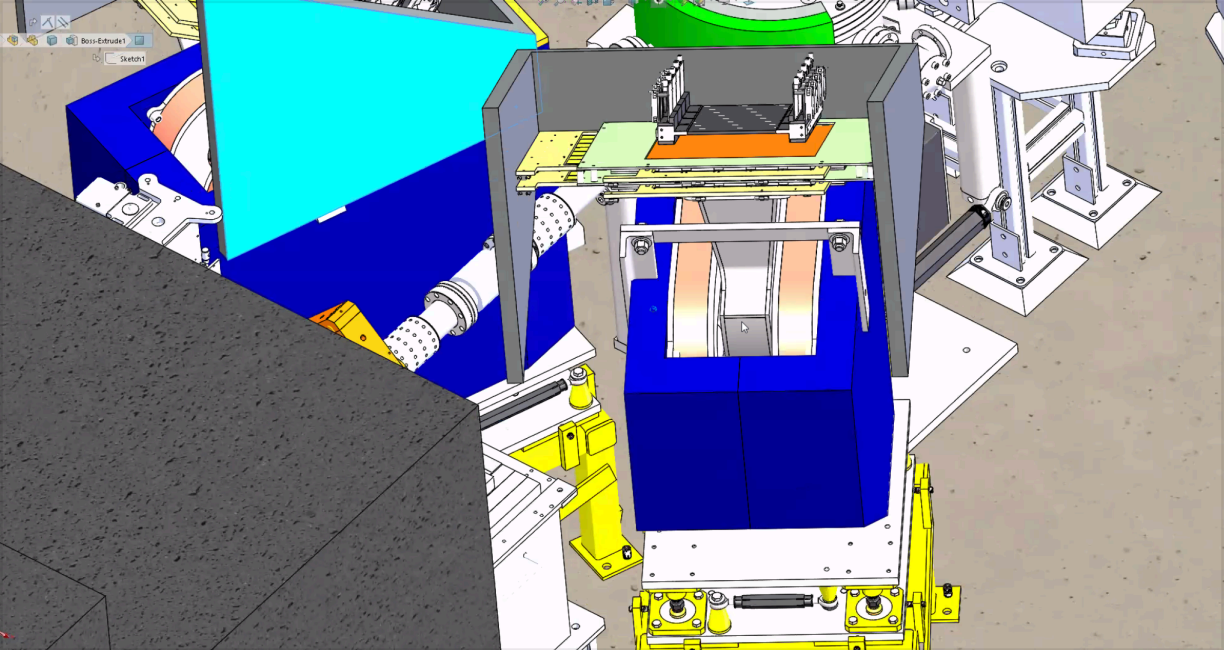
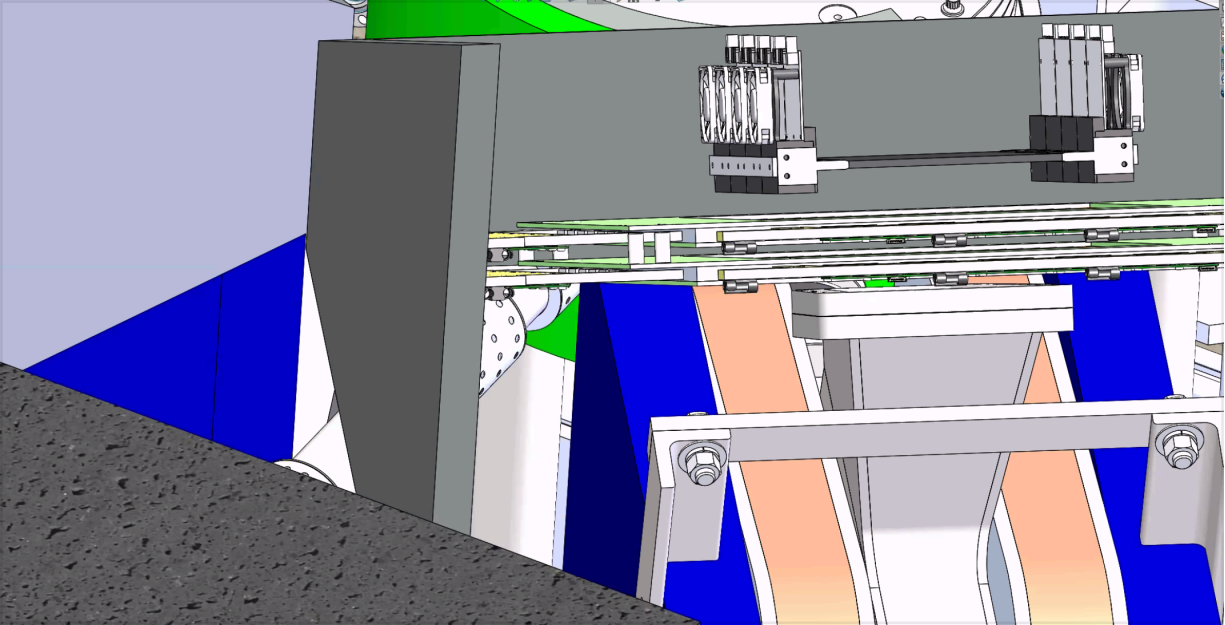
Sides of shielding are currently ~connected only through scintillators, but final design will obviously support this. Currently just placeholders.

small HDMI cable routing clamp is a mcmaster-carr part.

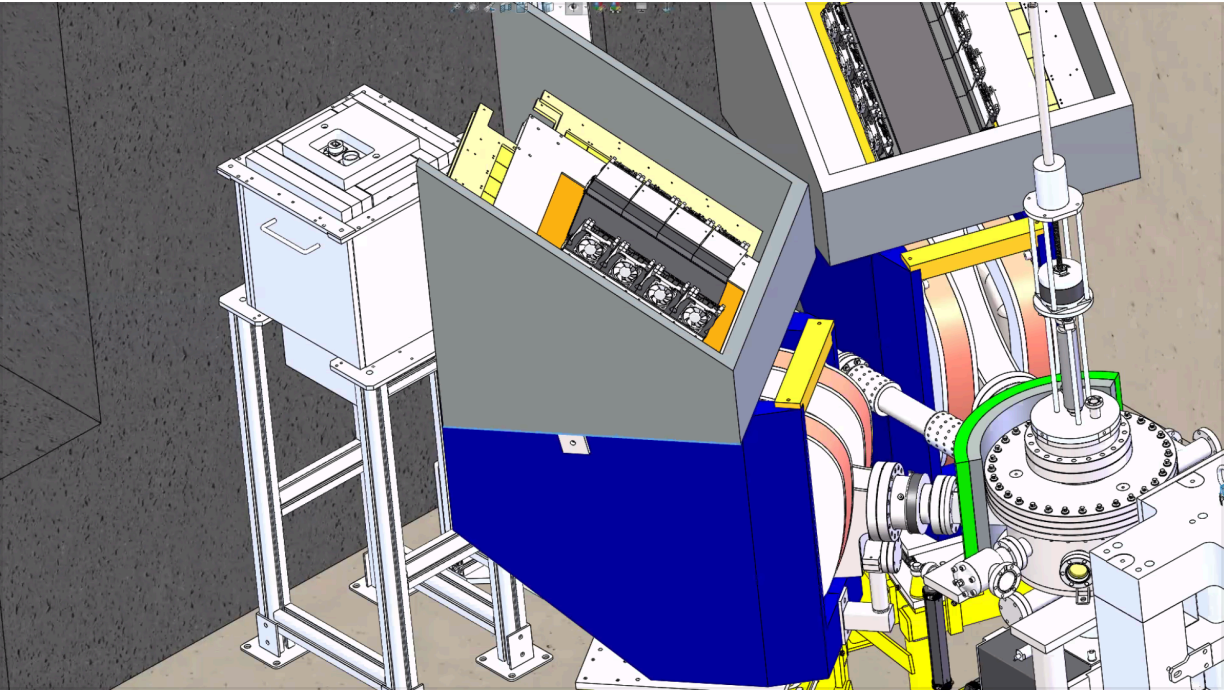
Jan reminds that the lead can only be removed by a crane if it is heavy (current 1" side plate is 60+ lbs) , so tight-fitting would make accessing connectors, cables etc difficult.

Again, this is just a placeholder design. A separate meeting will develop an actual design.
